West of Park Farm, Thornbury

Designers Response Report to Stage 1 Road Safety Audit

Project Ref: 39304 | Rev: - | Date: August 2018

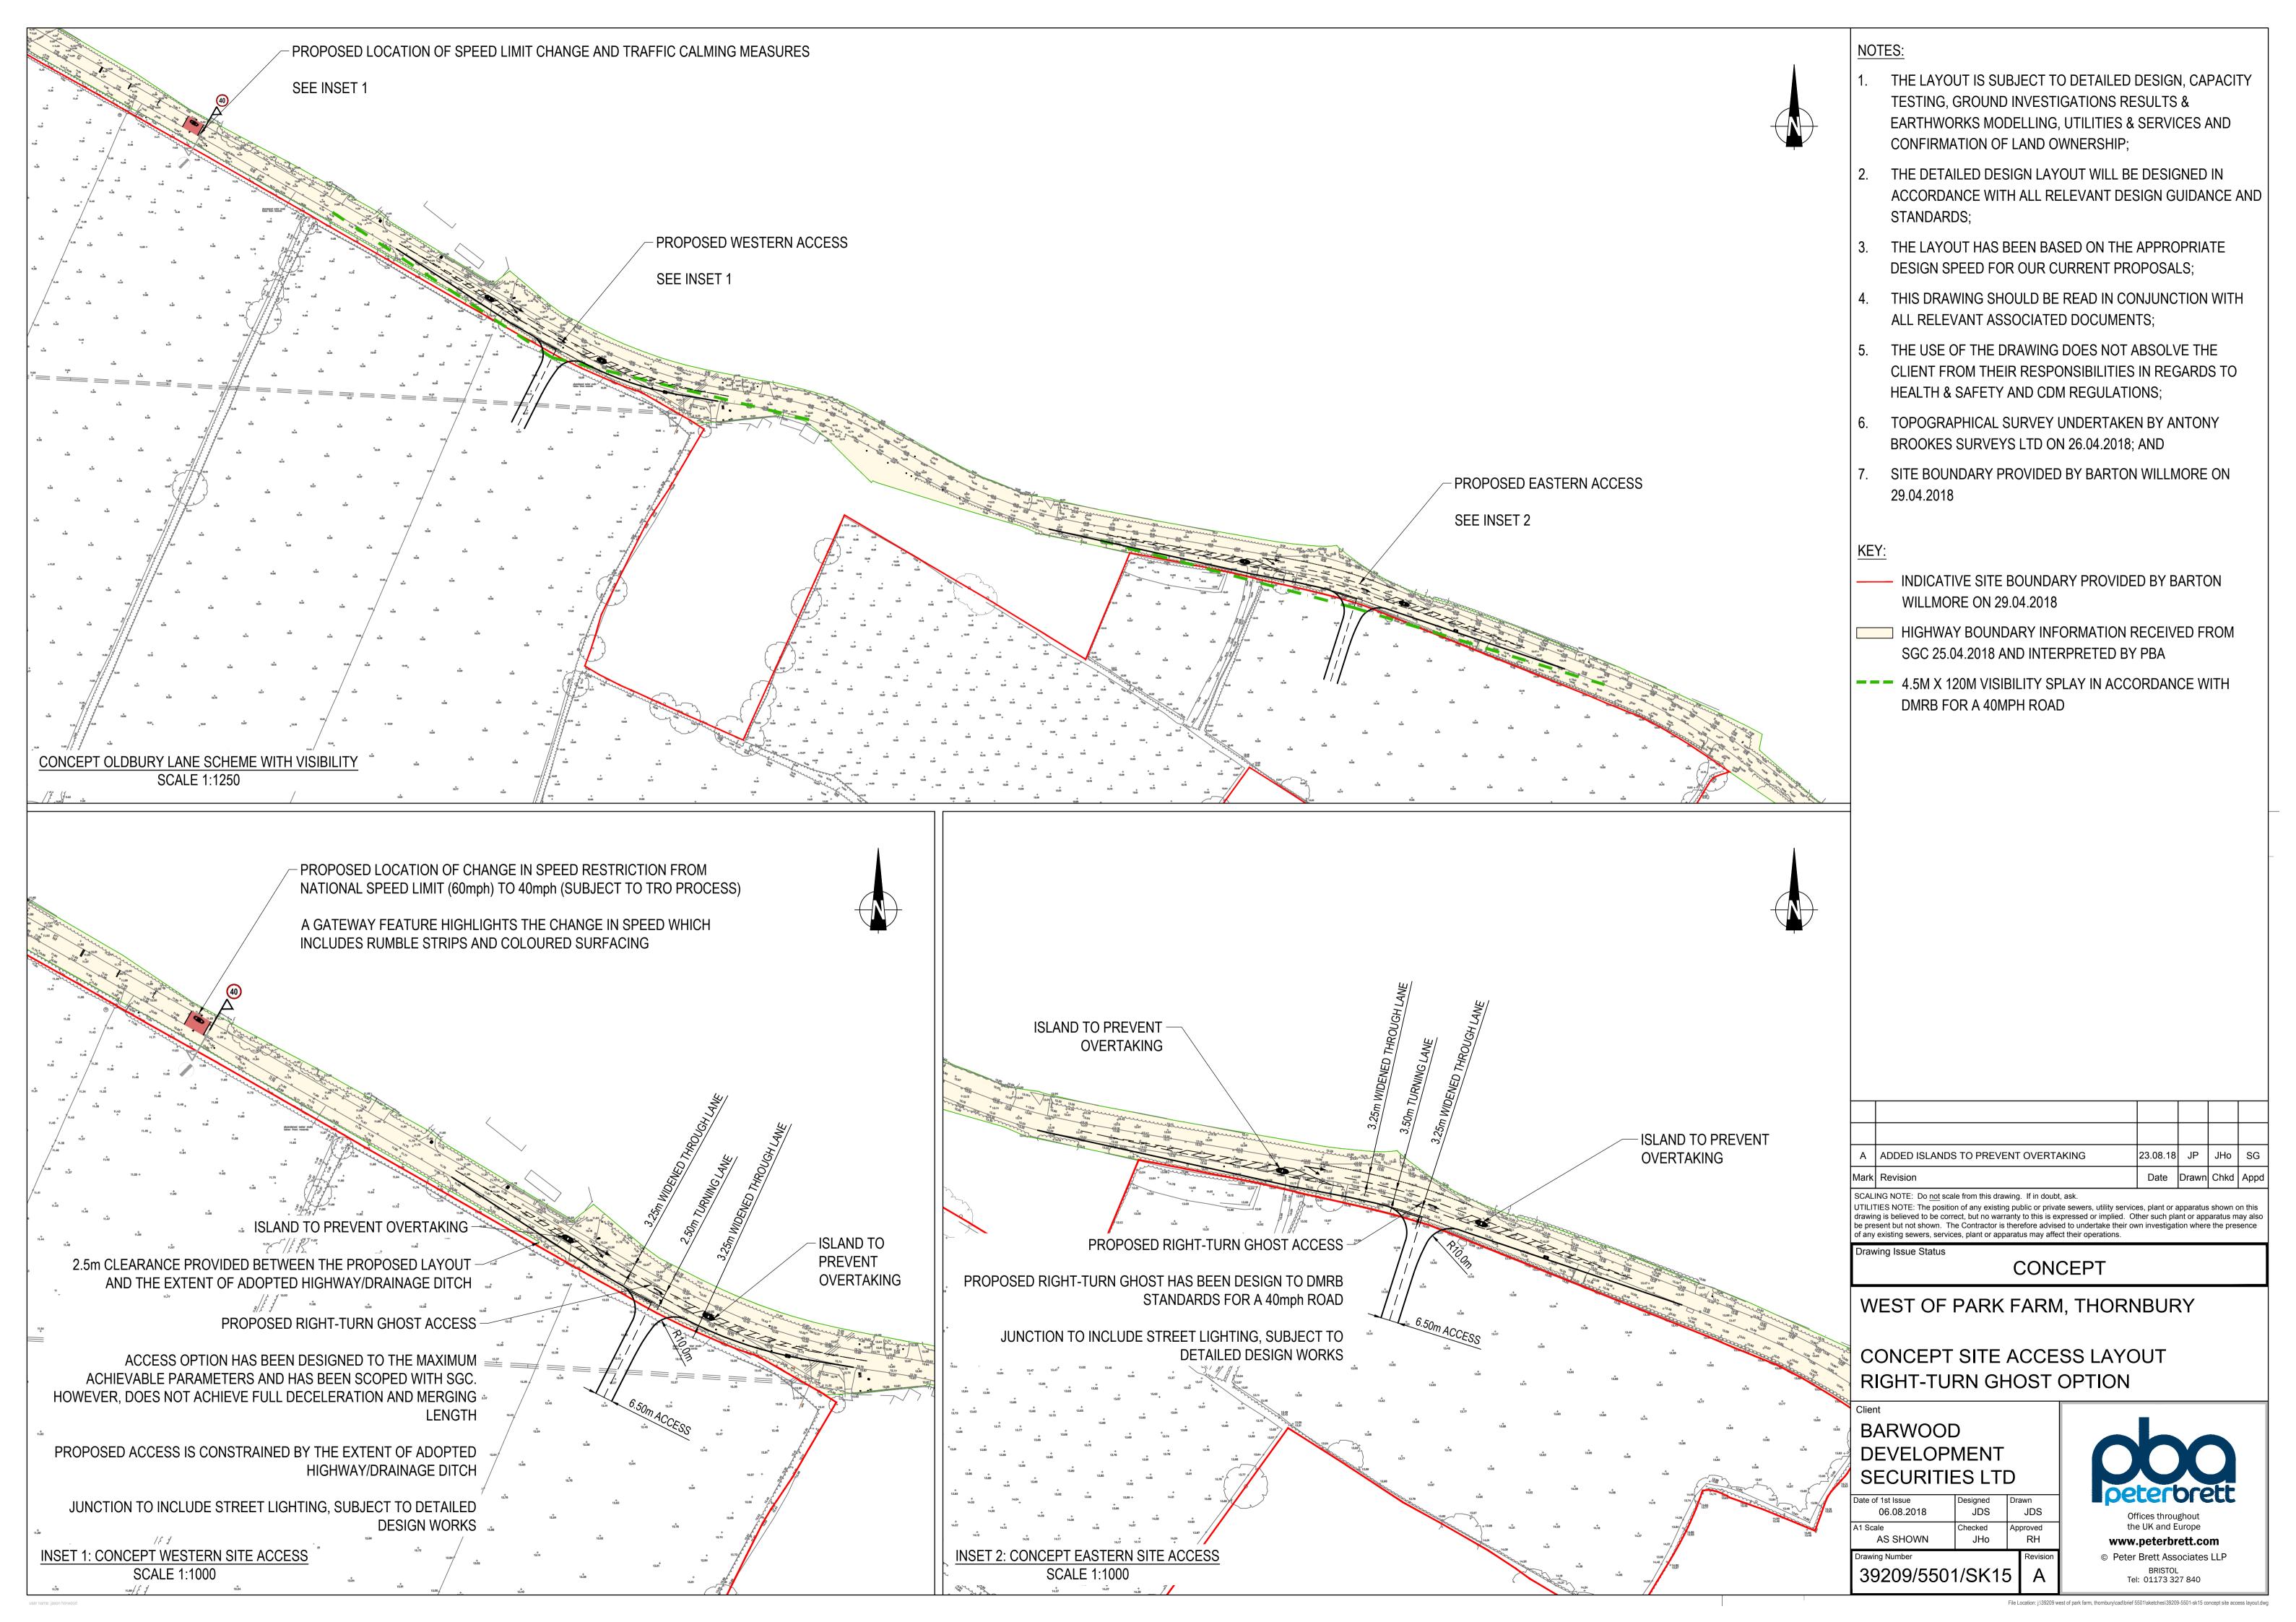
Summary: Risk of collisions involving overtaking vehicles

- 2.1.1 There is a risk that westbound drivers could use the additional lane to overtake slower-moving vehicles and collide with eastbound vehicles entering either of the right turn lanes.
- 2.1.2 Risk rating: Low

- 2.1.3 Solid islands, with appropriate signing, should be installed in the hatched areas of the proposed ghost island. Alternatively, double white centre lines should be installed to prohibit overtaking from either direction on the approach to and through the right turn lanes (this would also discourage the misuse of the western right turn lane by westbound vehicles turning right into properties on the north side of Oldbury Lane).
- 2.1.4 Risk rating if recommendation implemented: Low

- 2.1.5 The recommendation to Problem 2.1 is accepted.
- 2.1.6 Solid islands have been added to the hatched areas of the proposed ghost islands in locations shown in **Drawing 3902/5501/SK15 Rev A**, which will limit the opportunity to overtake using the right turn lanes. Appropriate signage will be specified at the detailed design stage.
